P5028A-03-S

Safety Service Note

P5028A Keysight Streamline USB Vector Network Analyzer

“POTENTIAL BURN INJURY (HIGH TEMPERATURE) HAZARD”

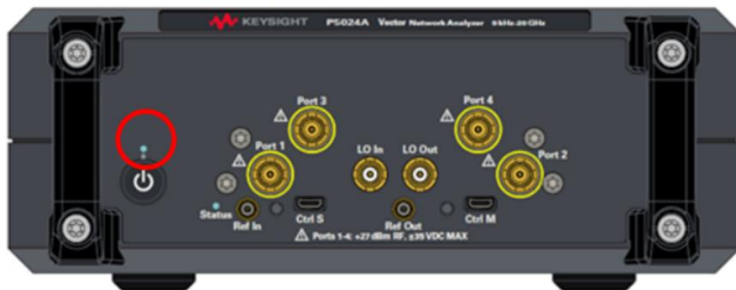
Symptom:

VNA fails to start with the following symptoms.

1. LED indicator (below circle) turns red.
2. cooling fan does not work
3. If user leaves the VNA with this LED indicator red without turning off power switch, it continues to overheat and becomes too hot.
